Comments to TFRWS-23-08 and tuned proposals introduced in TFRWS-24-02

2021-07-03, Per-Uno Sturk, Volvo Technology

This presentation was produced to aid the discussions in the 24th meeting, however updated with regards to slide 11 on request of the meeting.

Stepwise self-adjusting

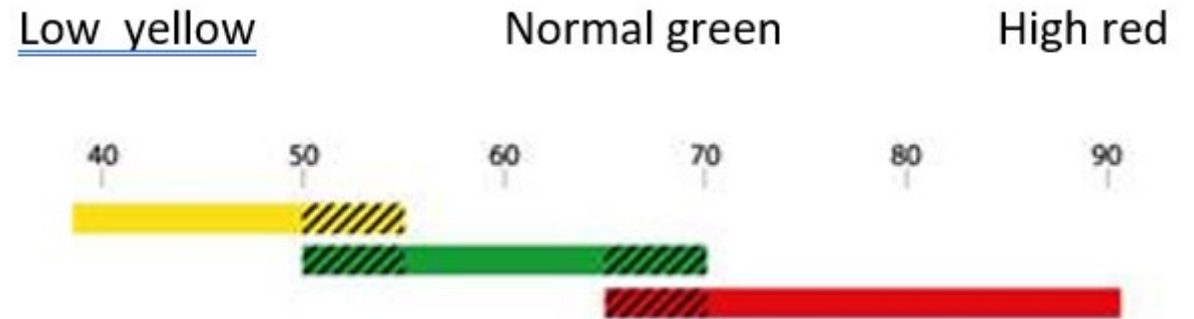
GREWUS: *The following graphic explains the meaning:*

Between 50dBA and 55dBA as well as 65dBA and 70dBA two modes are possible.

Explanation of this behaviour:

- The vehicle is in a quiet area, only few times the noise exceeds 50dBA than the Alarm remains in Low.*
- Over a wide range from 50-70dBA it will stay in normal mode.*

Part II: Measurement set-up & measured levels

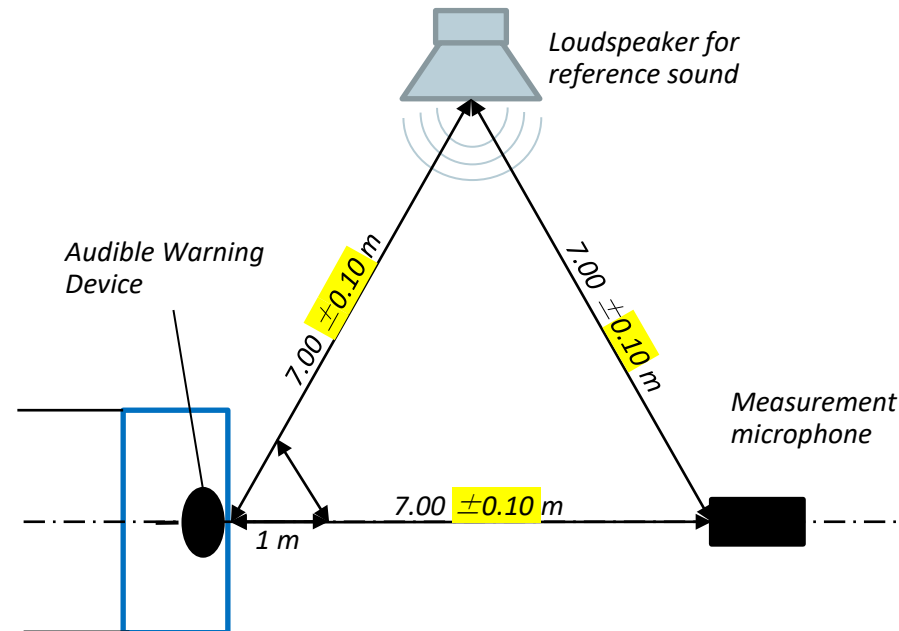
The “background” sound level shall be same at the self-adjusting RWS device and at the measurement microphone

the alarm shall produce a sound that exceed the background level measured at the microphone by more than 5 ± 4 dBA at 7 m.

Because the alarm is 7 m from the microphone the alarm shall produce a level of $17+5 \pm 4$ dBA higher than the background/reference sound level at 1 m – at the measurement position according to Part I.

Part I: Measurement set-up & measured levels

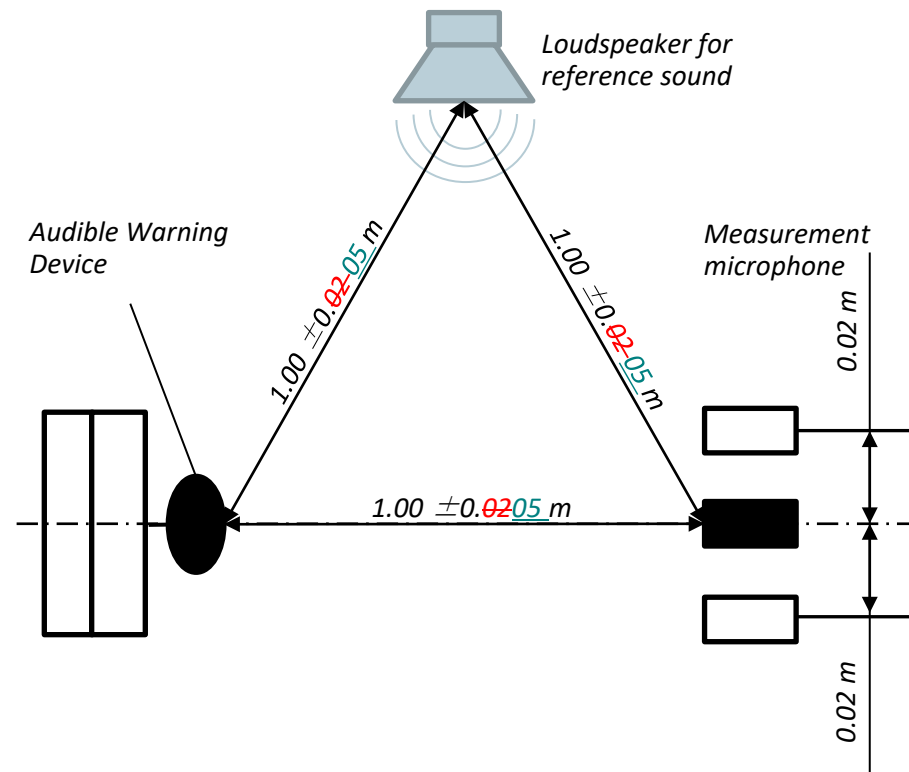
The loudspeaker for reference sound shall produce the same “background” sound level at the self-adjusting device and at the measurement microphone, simulating the background noise in a realistic situation.

The measurement shall *first* monitor the right reference sound level and *secondly* secure that the alarm produce a sound that exceed the background level by more than $17+5 \pm 4$ dBA.
